DOCKETED	
Docket Number:	25-BSTD-03
Project Title:	2028 Energy Code Pre-Rulemaking.
TN #:	270965
Document Title:	National Elevator Industry, Inc. Comments - Elevators - 15-minute shut-off adjustment
Description:	N/A
Filer:	System
Organization:	National Elevator Industry, Inc.
Submitter Role:	Public
Submission Date:	6/24/2026 11:00:24 AM
Docketed Date:	6/24/2026

Elevators - 15-minute shut-off adjustment

Section 120.6 – Mandatory Requirements for Covered Processes

DELETE THE FOLLOWING APPENDIX:

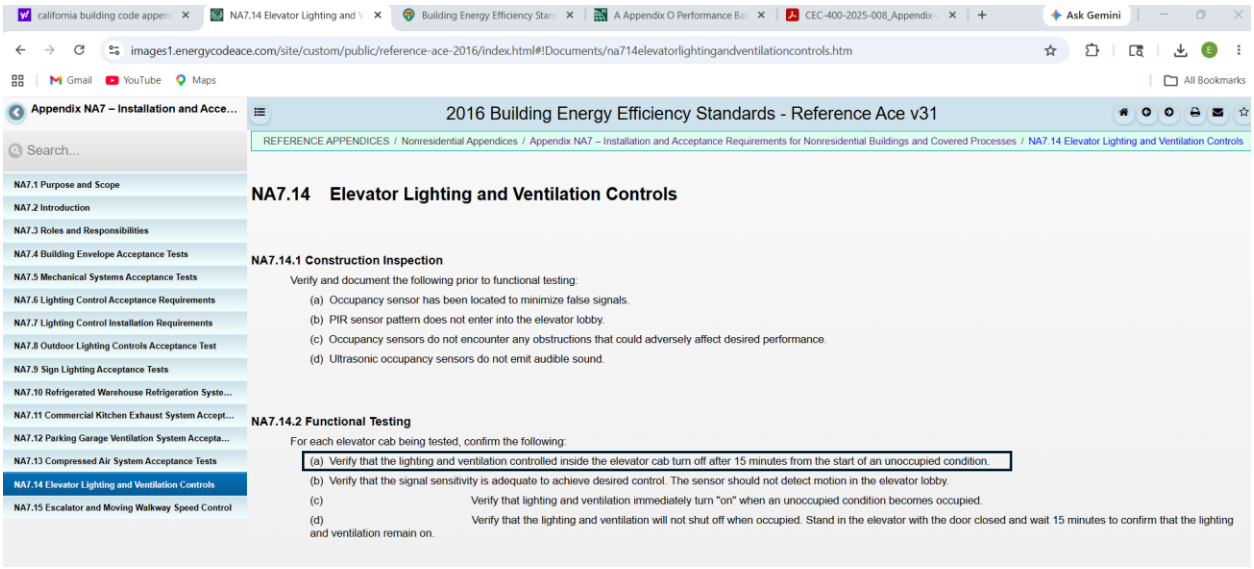
Reason: To improve energy efficiency and align with the requirements in ASHRAE 90.1-2022. To provide a simpler way to determine when lighting and ventilation should be turned off. The requirements for when to turn off the lights are already covered in 120.6(f)(3). The proposed requirements make it very simple to test the system. If no demand is placed on the system the lights and ventilation must turn off in 15 minutes or less. There is no need for a certification process and there is no need to check to see if the cab is occupied. If someone is in the cab they will either place demand on the elevator or exit unless they are trapped in which case demand is still present and the lighting and ventilation are addressed by 120.6(f)(4). Lack of demand is a simpler and more reliable way to turn off the lights and ventilation and save energy.
